ASSESSMENT REPORT

Section 96(1A) Modification Altis Warehouse and Logistics Hub (SSD 7173 MOD 2) Internal road and subdivision amendments

Figure 4: Proposed Draft Subdivision Plan

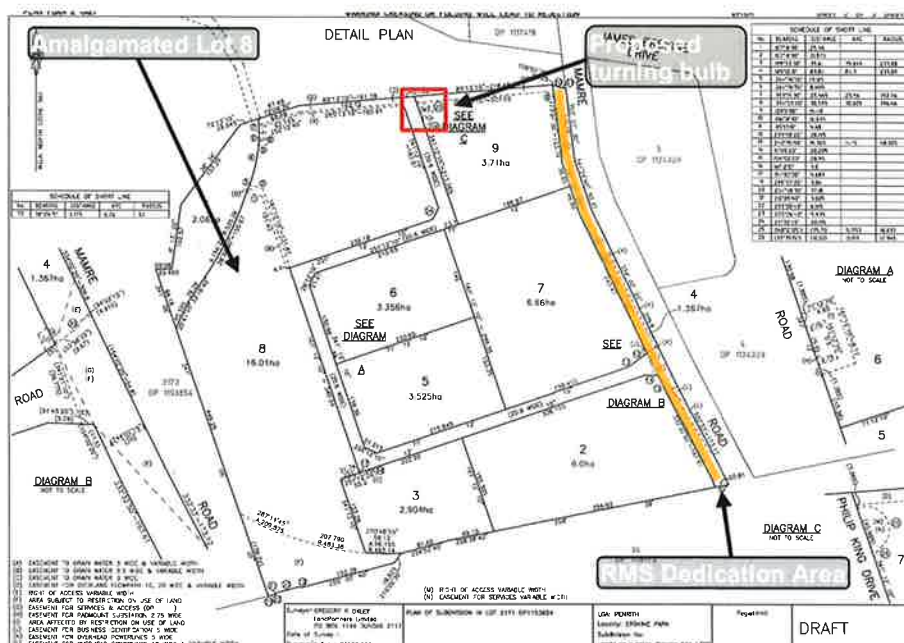
Issue	Assessment	Recommendation
Subdivision	- On this basis, the Department has recommended administrative changes to incorporate updated plans and documents. - The modification includes a revised subdivision plan to reflect the changes to the road network and clarify the land to be dedicated to the RMS for the widening of Mamre Road. - The Applicant also seeks to remove the lot size ranges from the development description to prevent potential conflict with the provisions for minor boundary changes under <i>State Environmental Planning Policy (Exempt and Complying Development) 2008</i>. - The proposed changes will amalgamate lots 4, 5 and 6 to create a new 'Lot 8', list the RMS dedication area as a separate lot, provides minor geometry changes to facilitate the interim seagull intersection off Mamre Road and re-number the lots on-site. - This will reduce the number of allotments from 10 to nine, excluding the internal estate road. - The Department considers the revised plan is consistent with the original development and the WSEA SEPP and concludes the revised plan would not adversely impact any approved developments currently under construction. - The Applicant has also provided an updated estate masterplan to reflect the proposed subdivision layout. While the cul-de-sac would remove indicative car parking for a future warehouse on Lot 9, this would be subject to assessment under a future DA. - The Applicant has also advised the staging of the development would not be impacted by the new lot layout. - The Department has therefore recommended the revised plan be incorporated into the development consent.	Incorporate updated plans into development consent

Figure 5: Proposed Location of Cul-de-sac

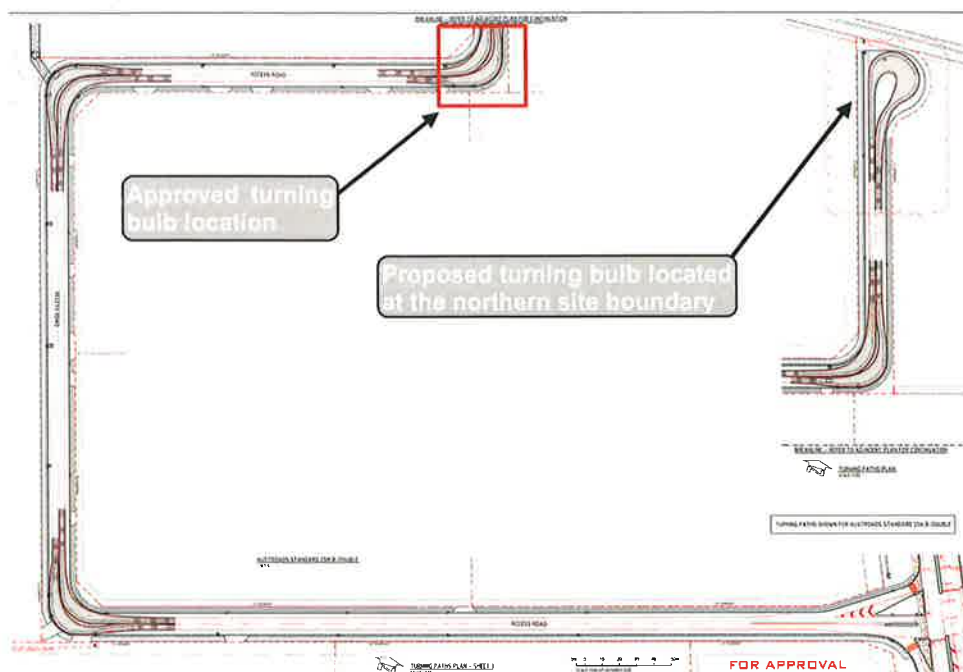
Issue	Assessment	Recommendation
Access	• The modification seeks to relocate the internal cul-de-sac further to the north along the internal estate road. The new location would also place the cul-de-sac on the eastern side of the road. • Revised drawings provided by the Applicant show the new design can accommodate a 180-degree U-turn of a 25 m B-Double vehicle. • RMS reiterated previous comments for all signposting to be at no cost to RMS. The Applicant agrees with this position. • The Department raised concern for the revised cul-de-sac for the future connection to James Erskine Drive. The Applicant has advised the cul-de-sac would be removed when this connection is made. • The Department considers the revised location of the cul-de-sac is acceptable and would reduce potential traffic conflicts in the estate, when operating, until the estate road is connected to the fourth leg of the James Erskine Drive intersection.	• Administrative changes to include updated plans.
